DRAFT REPORT

Dam Safety Assessment of CCW Impoundments

Joppa Plant

May 27, 2010

DRAFT FIGURE 3

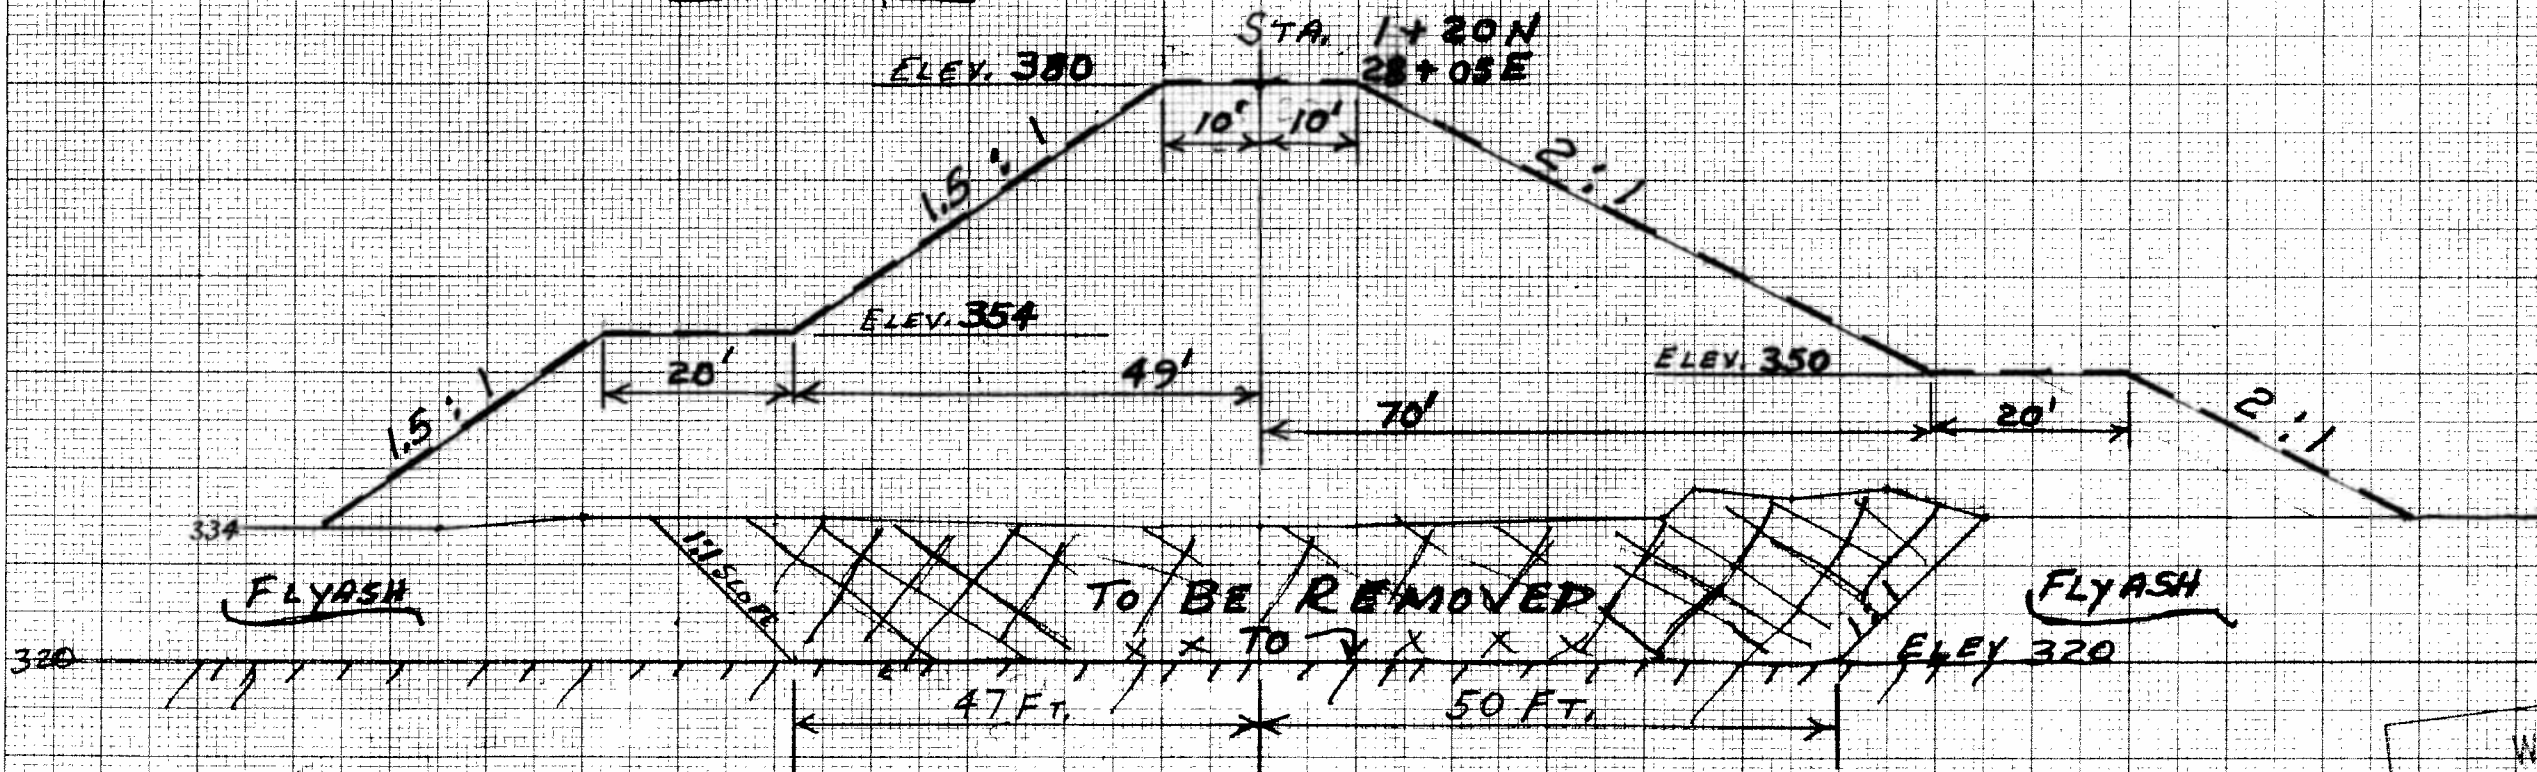
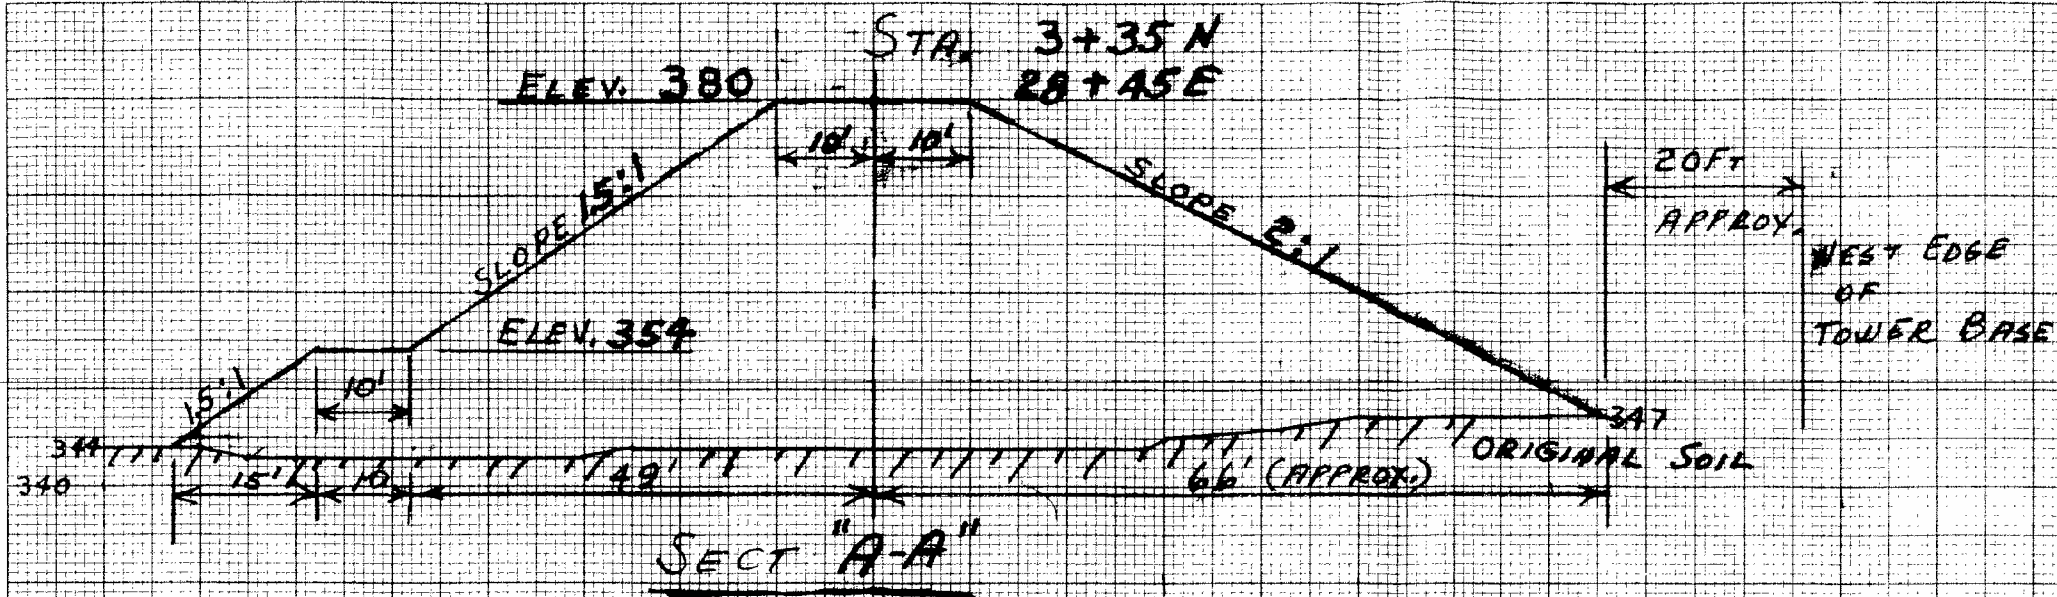
- Seepage was observed in multiple locations along the outboard toe of the embankment. The most significant area of seepage is located approximately 500 feet north of the power lines (Photos 23 & 24). Other areas where seepage was observed include an area approximately 200 feet south of the power lines and along the southern embankment of the Southern Pond. The approximate locations of seepage are identified on Figure 3.

AP-109 SH. 1

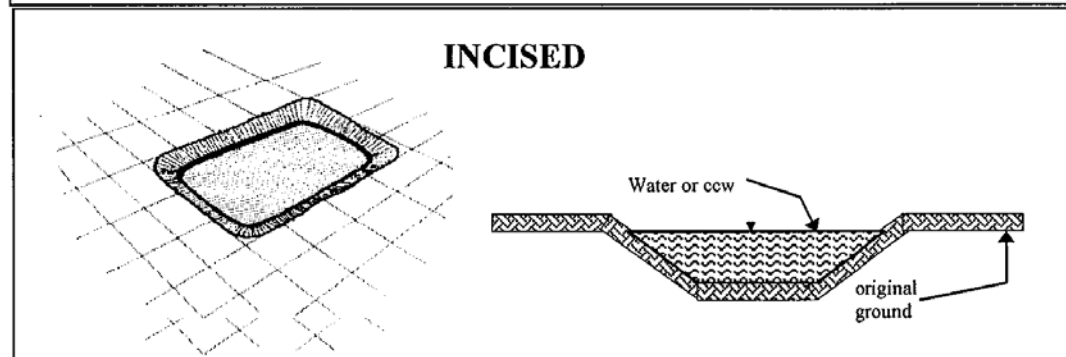
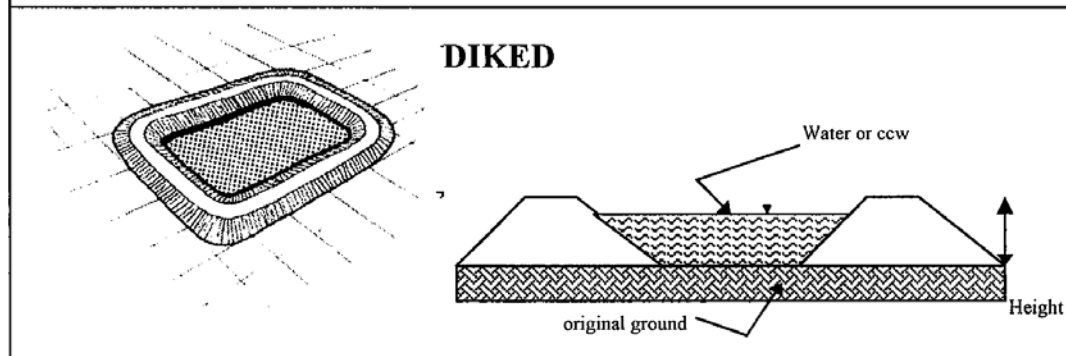
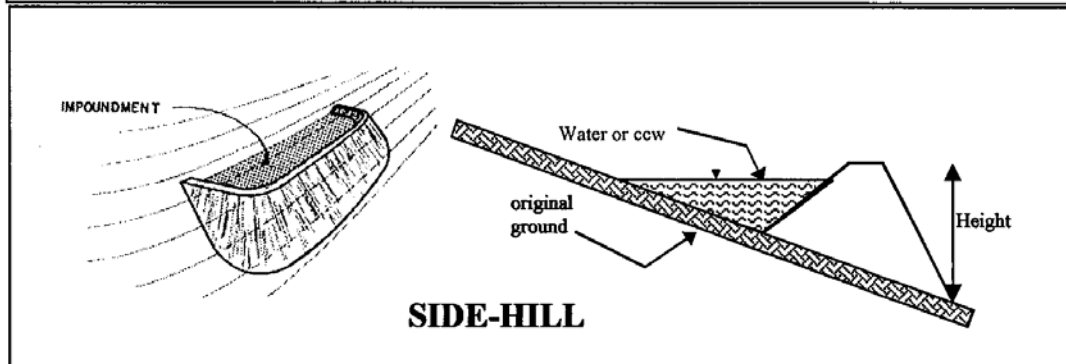
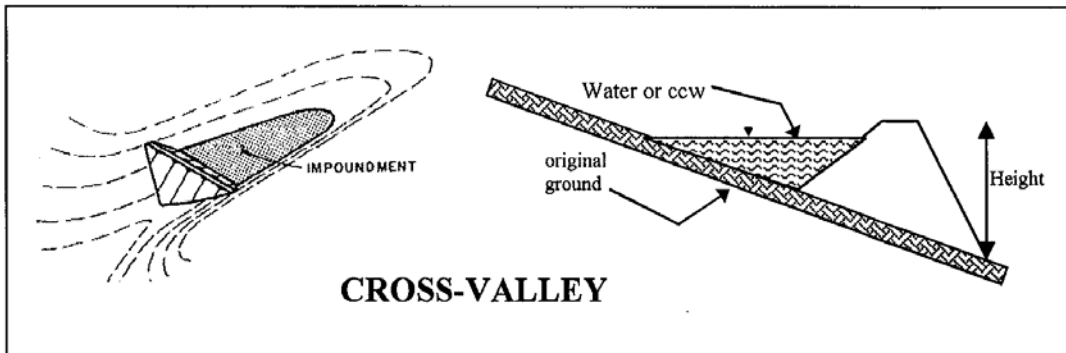
- The outboard slope is steeper than generally recommended for dam and dike construction. The design drawings (See attached EEI Drawing AP-109) indicate the slope should be 2H:1V, but the observed slope appeared to be steeper and matched the 1.5H:1V slope of the Northern Pond.

- Based on Drawing AP-109, Sht. 1 (attached), the Southern Pond embankment was keyed into a suitable foundation through a layer of fly ash for a portion of the embankment. Section A-A, which is indicative of construction in the area near the power lines (Dwg. 4229-8211, Sht. 1), indicates that this section of the embankment was not keyed into the underlying foundation.

- Outboard slopes – remove deleterious vegetation and continue regular maintenance of the slopes; repair any areas of sloughs, slides and erosion.
- Outboard toe – investigate the extent of seepage, monitor the seepage on a regular basis, and develop alternatives for treating the deteriorated sections of the embankment.
